APPLICANT: John Rife _____ **PETITION No.:** V-135
PHONE: 770-820-1597 _____ **DATE OF HEARING:** 12-11-13
REPRESENTATIVE: R. Newsom _____ **PRESENT ZONING:** R-15/OSC
PHONE: 770-820-1597 _____ **LAND LOT(S):** 538
TITLEHOLDER: John Rife, Jr. and Ree Rife _____ **DISTRICT:** 16
PROPERTY LOCATION: On the west side of _____ **SIZE OF TRACT:** 0.23 acre
Windstone Circle, north of Lassiter Road _____ **COMMISSION DISTRICT:** 3
(2966 Windstone Circle).

TYPE OF VARIANCE: Increase the maximum allowable impervious surface from 35% to 38.95%.

COMMENTS

Application for Variance

ABOVE THE GROUND AS BUILT SURVEY PREPARED FOR

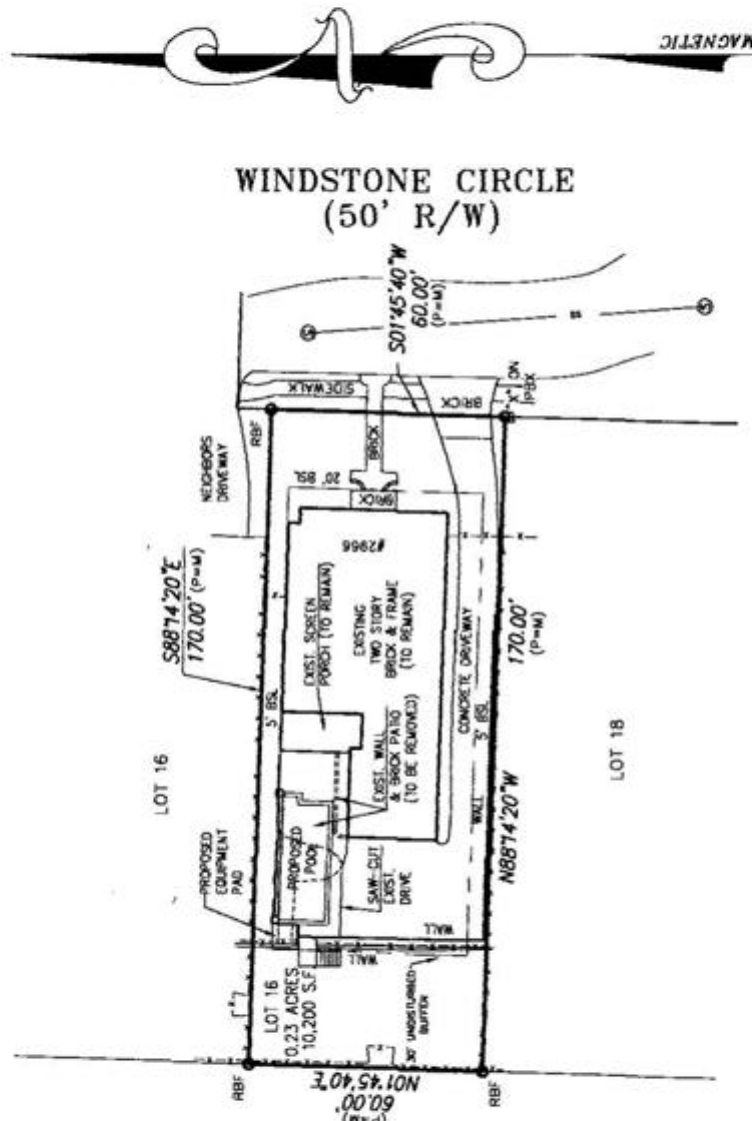
STORMWATER MANAGEMENT: The existing impervious coverage is 40.0%. The proposed improvements will result in a net reduction in impervious area by 80 square feet and reduce the coverage to 39.5%.
